SERVICE LETTER 246

E-Dump System, Water Rudder Retract Cable Interference

Aircraft Makes/Model(s):	Float Model(s):	Compliance: Optional	By: MAS
Air Tractor AT-802A (Only Model)	10000A	Part Number: 1005051	Approved: DRH
		Date: 4/15/2026	Revision: C

Figure 1 – Example of Interference

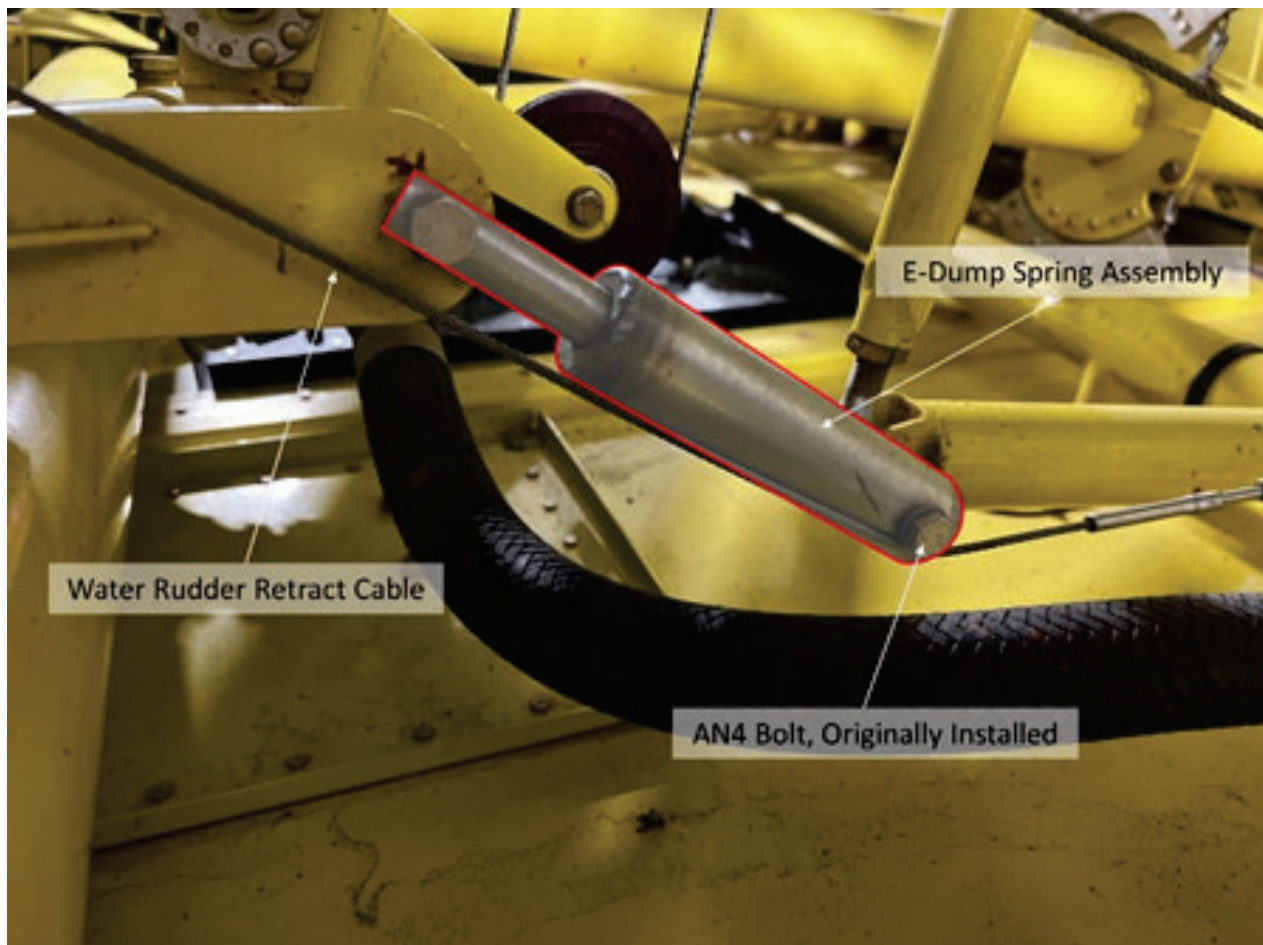
The manual (non-electric) water rudder retract cable may become caught on the Emergency Dump Spring Assembly (Air Tractor P/N 71134-1) due to the water rudders being able to "bounce" while in the retracted position, creating momentary slack in the cable.
